## HISTORIC AND DESIGN REVIEW COMMISSION

### Agenda Item No: 6

**HDRC CASE NO:** 2015-153  
**ADDRESS:** 3501 BROADWAY  
**LEGAL DESCRIPTION:** NCB 6299 BLK LOT 197 AND 198  
**ZONING:** C2 RIO-1  
**CITY COUNCIL DIST.:** 2  
**APPLICANT:** Elizabeth Haynes  
**OWNER:** Richard Lange/The Acorn A School For Young Children  
**TYPE OF WORK:** Addition  
**REQUEST:**

# PROPOSED SITE PLAN

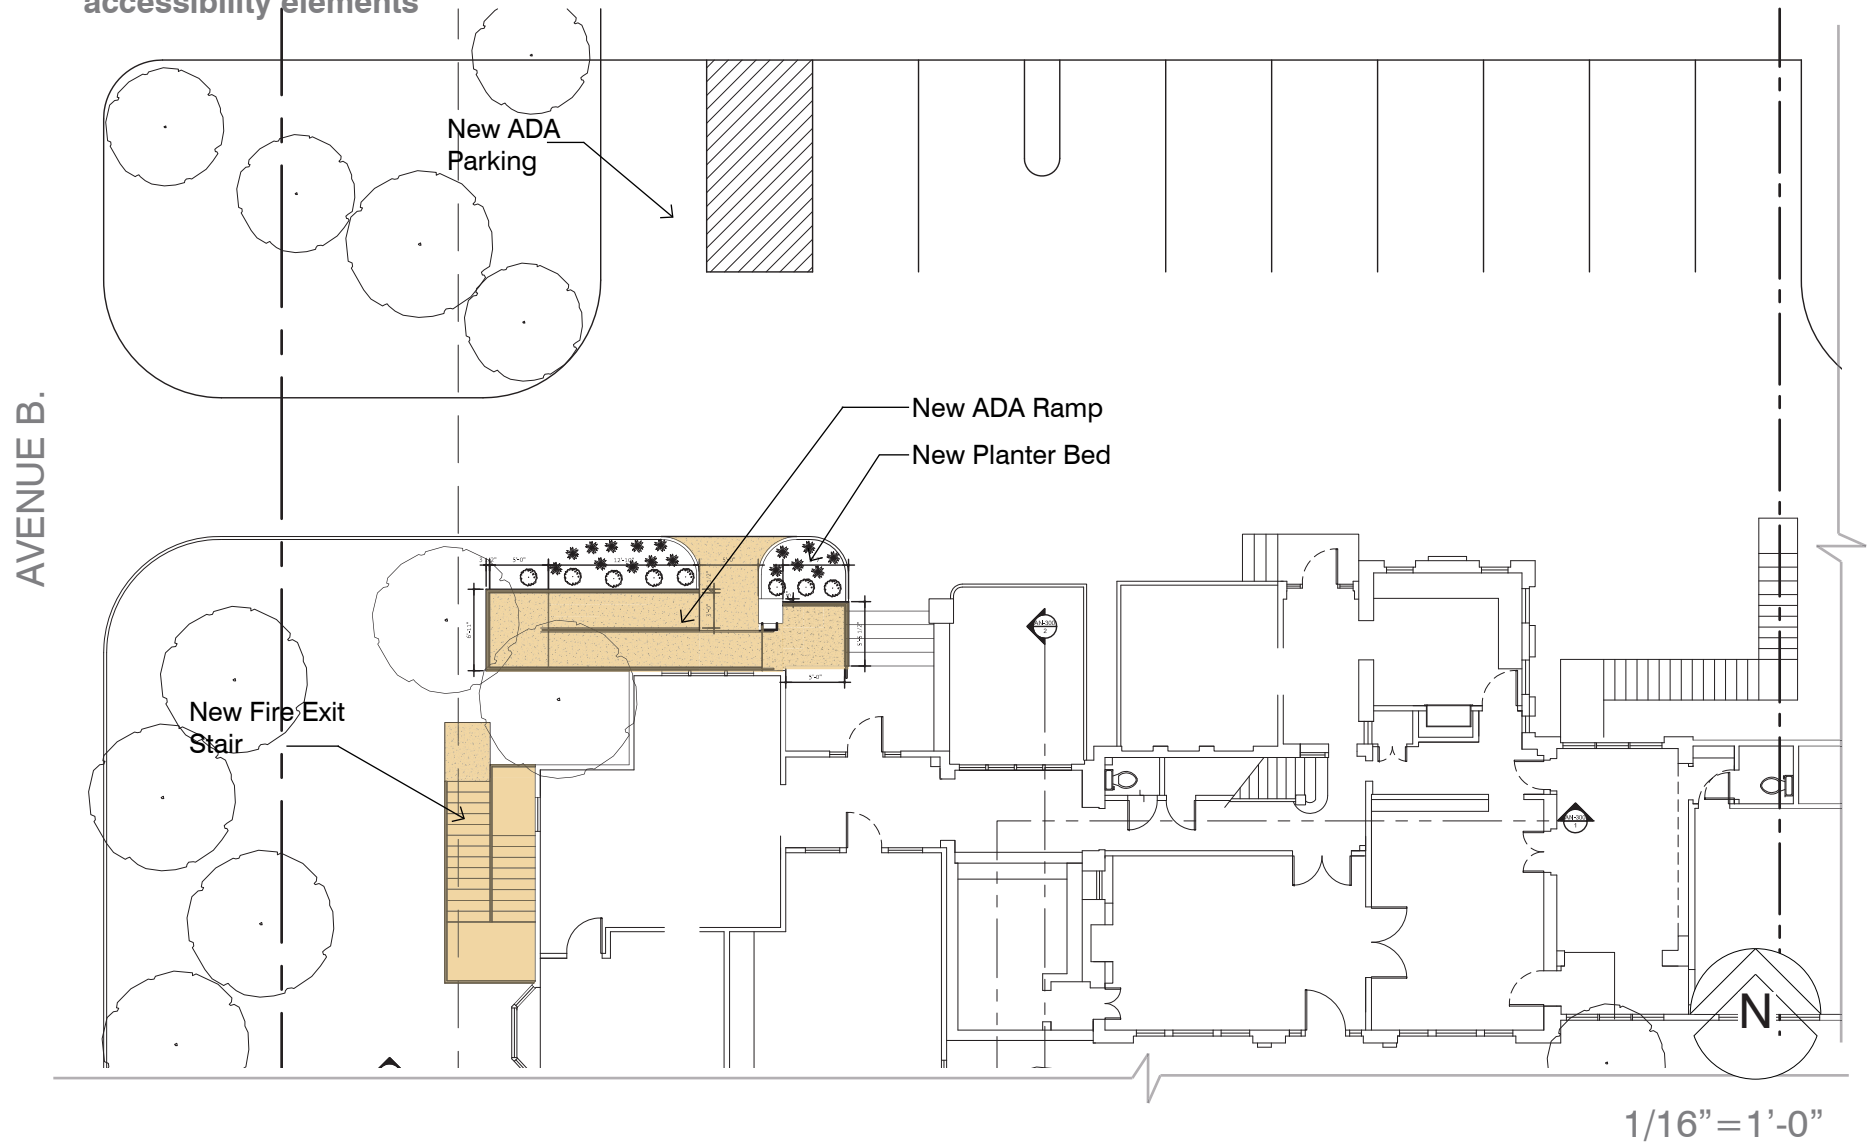
- f. The applicant has proposed to install an ADA accessible ramp on the north side of the site adjacent to the existing parking lot. The applicant has proposed for the ramp to include a stucco base and brick cap to match the materials of the existing structure. This is consistent with the UDC Section 35-674(d)(1) regarding the use of indigenous and traditional building materials.

- g. The applicant has proposed to install a new planting bed to buffer the landing of the proposed ADA ramp. The proposed planting bed is to match the depth of the existing planting bed which is to the west of the proposed, new planting bed. The applicant has proposed planting materials that already exist on the site. This is consistent with the UDC Section 35-673(f)(1) in regards to plant materials.
- h. The applicant has proposed to remove an existing ten inch diameter Cedar Elm. A tree permit will be required to remove this tree. Staff recommends that the applicant mitigate in the form of a two inch caliper small specie tree.

Staff recommends approval of items #1 through #4 based as submitted based on findings a through h.

WEST ELEVATION (AVENUE B.)  
1/16" = 1'-0"

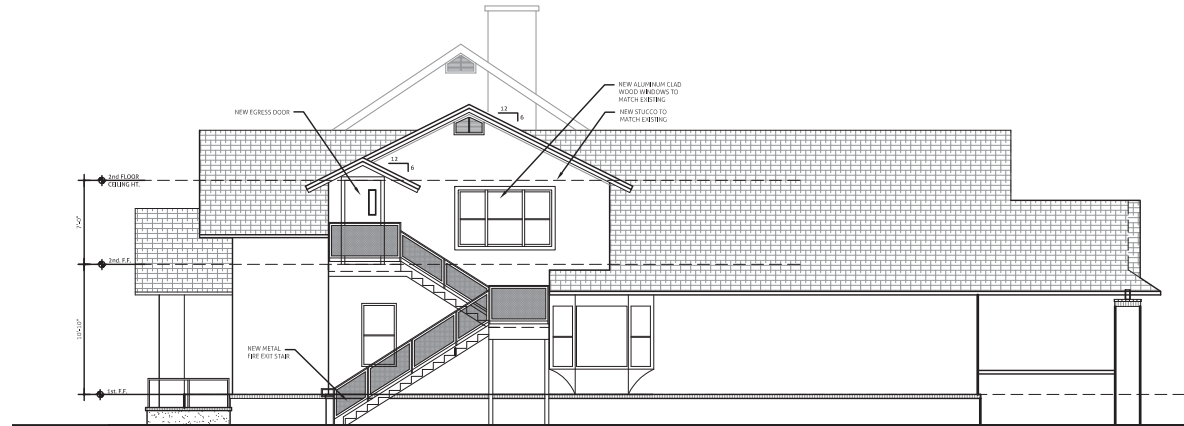
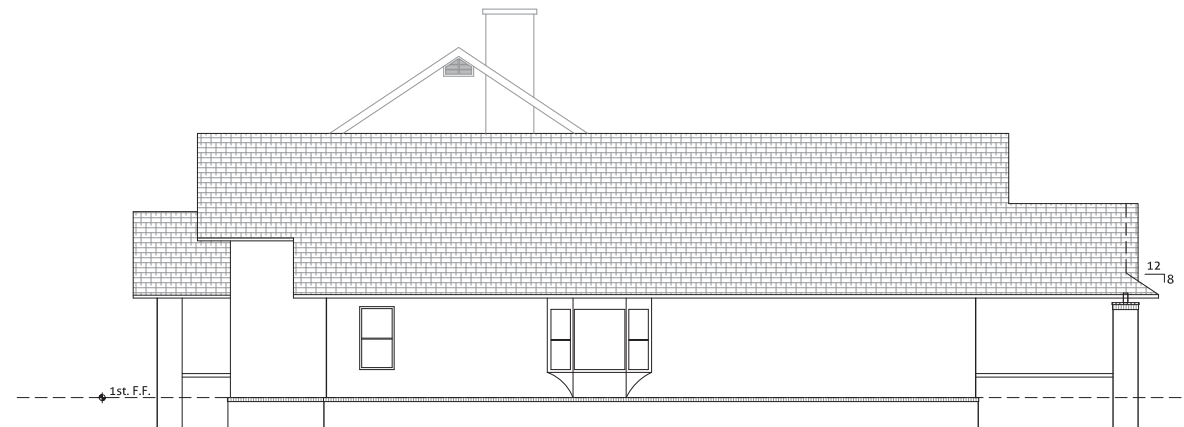
- e. The applicant has proposed to install an egress door as well as egress stairs on the west façade of the proposed addition facing Avenue B. Access to the ground level from the proposed egress door is in the form of a new metal fire exit stair. Both the proposed door as well as the proposed egress stair are appropriate in size and scale for their use and are consistent with the UDC Section 35-674(e)(3) in regards to entrances.

SOUTH ELEVATION (BRACKENRIDGE DR.)  
1/16" = 1'-0"

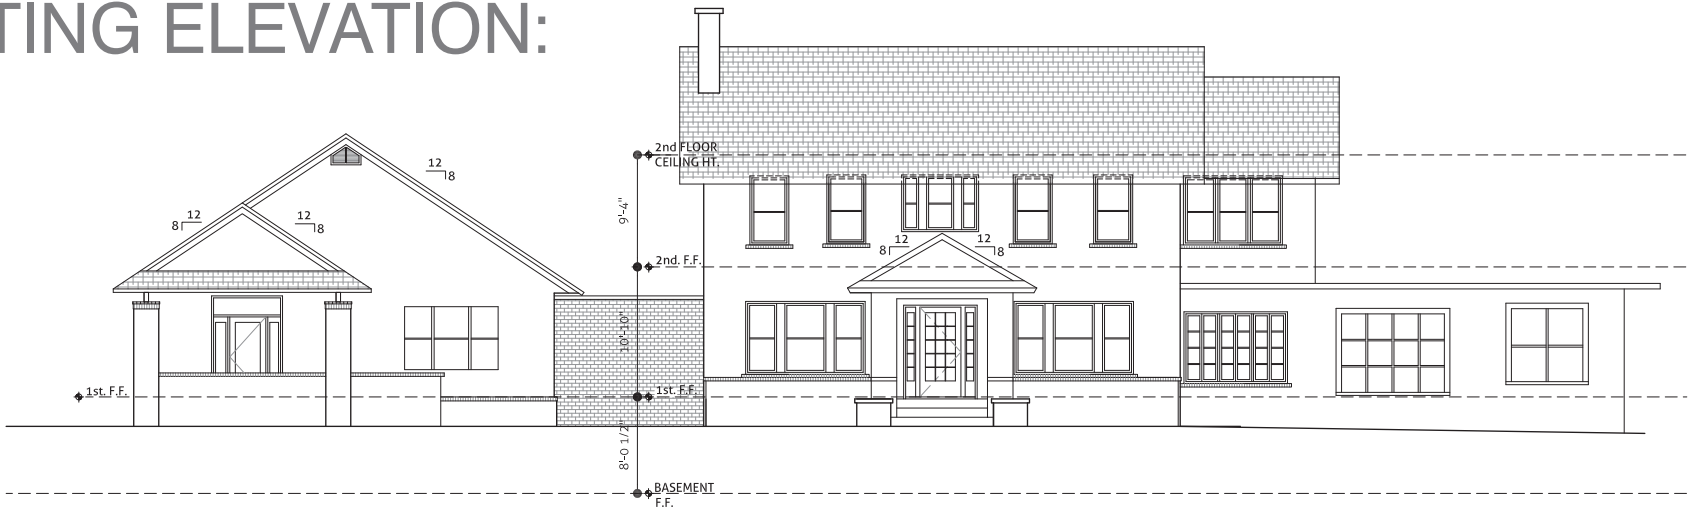
- b. The UDC Section 35-674(b) states that a building shall appear to have a human scale through the use of familiar forms and elements that are interpreted in human dimensions. The applicant has proposed to construct the new addition above an existing addition constructed in 1993. The applicant has proposed to include a similar roof pitch and form, however a reduced height in order to distinguish between the original structure and the new addition. This is consistent with the UDC.

- c. The existing addition features green stucco siding, aluminum clad wood windows and a grey composite shingle roof. The existing addition shares similar materials with the original structure, which also includes wood siding. The applicant has proposed to use each of the existing materials in the proposed addition. This is consistent with the UDC Section 35-674(d)(1) regarding the use of indigenous and traditional building materials.

- d. The applicant has proposed for the windows of the addition to match or relate those of the existing structures in regards to window material. According to the UDC Section 35-674(e)(2), windows help provide a human scale and so shall be proportioned accordingly. The proposed windows as well as their size, scale and arrangement are consistent with the UDC.
